Access Compliance Report Public Rights-of-Way (Curb Ramps)

Main Street: BASKERVILLE_RD Cross Street: BURNEY_PL Location: E

ADA ID: RPAT211202123544 Ramp Type: Type 1 - Perpendicular Diagonal Initial Pass/Fail: Pass Overall Compliance: No Severity Score: 14

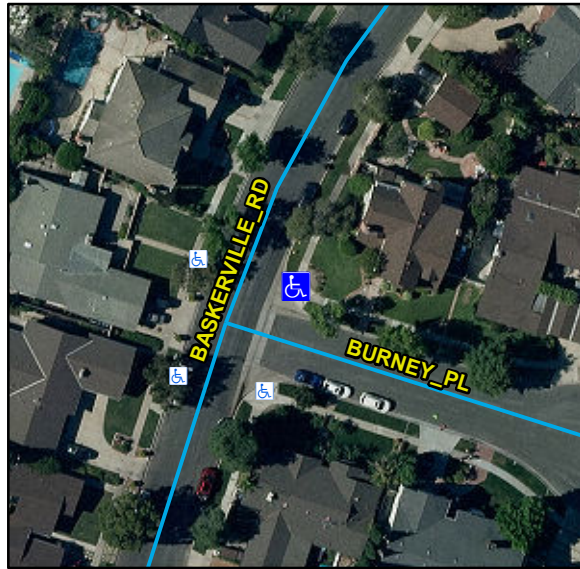
Remove & Replace Curb Ramp With Two New Directional Ramps or Equivalent. Remove & Replace Gutter.

R304.2.2, R204.3, R304.2.1, R304.2.2-Perp, R304.3.2-Para, R305, R304.5.3, STD 1115

Compliance	Description	Data	Compliance	Description	Data
N/A	Ramp Length (in)	82	N/A	Flare Type LT	
Yes	Ramp Width (in)	60			Sloped
Yes	Ramp Run Slope (%)	5	N/A	Flare Slope LT (%)	7.2
Yes	Ramp Cross Slope (%)	0.7	N/A	Flare Traversable LT	No
N/A	Landing Present	Yes	N/A	Flare Type RT	
N/A	Landing Length (in)	36			Sloped
Yes	Landing Width (in)	56	N/A	Flare Slope RT (%)	6
No	Landing Run Slope (%)	3	N/A	Flare Traversable RT	No
Yes	Landing Cross Slope (%)	0.8	No	DWS Provided	No
N/A	Landing Movement Obstructed?	No	N/A	DWS Contrast	N/A
	Landing Movement Type	N/A	N/A	DWS Length (in)	N/A
N/A	Landing Shared	No	N/A	DWS Full Width	N/A
N/A	Clear Space	Yes	N/A	DWS Offset Left (in)	N/A
N/A	Clear Space To Crosswalk (in)	48	N/A	DWS Offset Right (in)	N/A
N/A	Marked Crosswalk 1	No	N/A	Marked Crosswalk 2	No
	Crossing 1 Direction	NW		Crossing 2 Direction	SW
	Marked Crosswalk 1 Width (in)	N/A		Marked Crosswalk 2 Width (in)	N/A
N/A	Ramp Inside Crosswalk 1	N/A	Yes	Ramp Inside Crosswalk 2	N/A

Crossing 1 Slope (%)	4.9		Crossing 2 Slope (%)	1.2
	Crossing 1 Cross Slope (%)	1		Crossing 2 Cross Slope (%)	1.3
Yes	Gutter Ponding	No	No	Curb Slope	8.4
Yes	Gutter Lip Height (in)	0		Road Run Slope (%)	0.8
Yes	Gutter Run Slope (%)	1.3		Road Cross Slope (%)	2
No	Gutter Cross Slope (%)	2.2			
Yes	Overall Surface Condition: Acceptable		No	Perp Joint Present	No
	Cross Gutter Present?	Yes		Spandrel Present?	Yes
	Replace Cross Gutter?	No		Replace Spandrel?	No
